Access Compliance Report

Public Rights-of-Way

(Curb Ramps)

Intersection ID: 12450	Main Street: N_ALEXANDER_ST	Cross Street: E_9TH_ST	Location: S
ADA ID: F1CFA1AC7EDF	Ramp Type: PerpDiag	Initial Pass/Fail: Fail	Overall Compliance: No
			Severity Score: 21.25

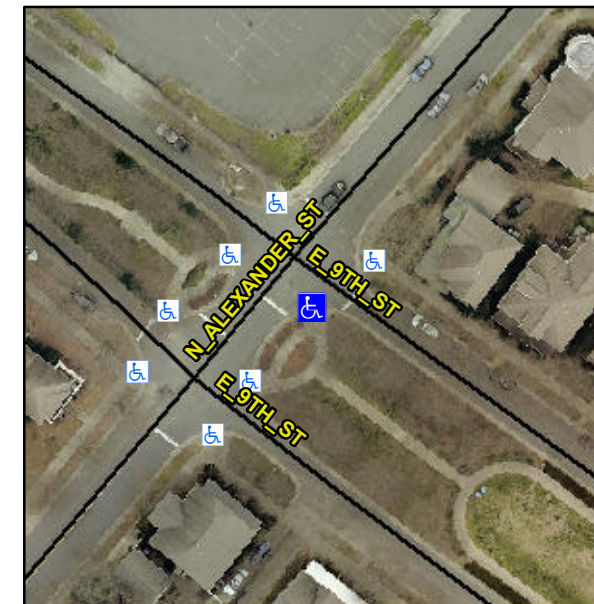
R304.5.1, R304.2.2

Compliance	Description	Data	Compliance	Description	Data
N/A	Ramp Length (in)	72.0	No	Ramp Slope (%)	10.0
No	Ramp Width (in)	38.0	Yes	Ramp XSlope (%)	1.3
N/A	Flare Type LT	N/A	N/A	Flare Type RT	N/A
N/A	Flare Slope LT (%)	N/A	N/A	Flare Slope RT (%)	N/A
N/A	Flare Traversable LT?	N/A	N/A	Flare Traversable RT?	N/A
N/A	Landing Length (in)	N/A	N/A	DWS Provided?	N/A
N/A	Landing Width (in)	N/A	N/A	DWS Contrast?	N/A
N/A	Landing Slope (%)	N/A	N/A	DWS Length (in)	N/A
N/A	Landing X Slope (%)	N/A	N/A	DWS Full Width?	N/A
N/A	Landing Curb? (Y/N)	N/A	N/A	DWS Offset (in)	N/A
N/A	Shared Landing?	N/A			
N/A	Gutter Ponding?	N/A	N/A	Gutter Slope (%)	N/A
N/A	Gutter Lip Ht (in)	N/A	N/A	Gutter X Slope (%)	N/A
N/A	Painted X Walk1?	No	N/A	Painted X Walk2?	No
	X Walk 1 Direction	To NE		X Walk 2 Direction	To NW
N/A	X Walk 1 Width (in)	N/A	N/A	X Walk 2 Width (in)	N/A
	X Walk 1 Slope (%)	0.9		X Walk 2 Slope (%)	2.7
	X Walk 1 X Slope (%)	2.5		X Walk 2 X Slope (%)	0.4

Remove & Replace Curb Ramp With Two New Directional Ramps or Equivalent.
